3	302-003	COMPONENT & SYS ID INDEX
2	302-002	SYMBOLS INSTRUMENTATION
1	302-001	SYMBOLS & SW DIAGRAM
NO.	REV. NO.	REF.
REFERENCES

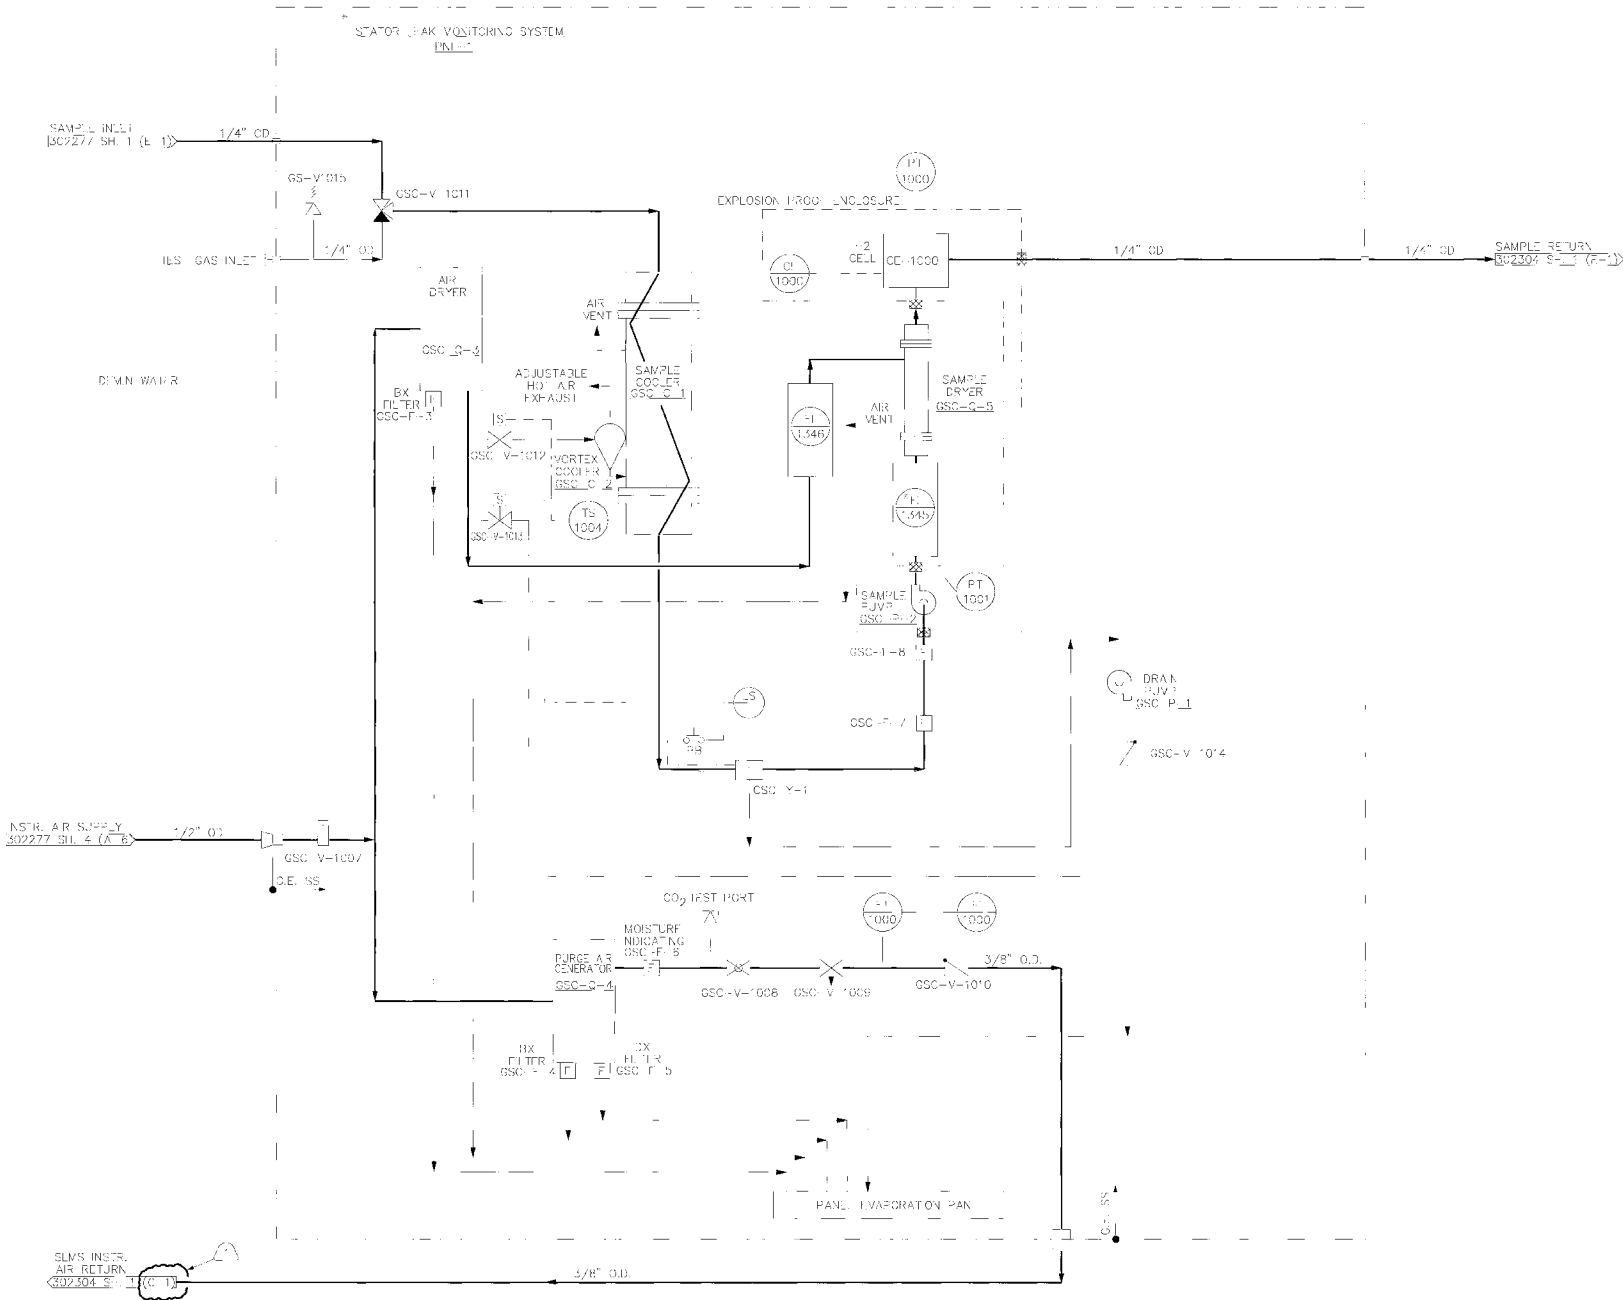
REV	DESCRIPTION
1	3-7 REV. TO INCORPORATE AN ADMINISTRATIVE REV. PER AR 0106777, CHANGED COORDINATION FLAG COORDINATES FOUND AT B 7 FROM F-3 TO C-1.
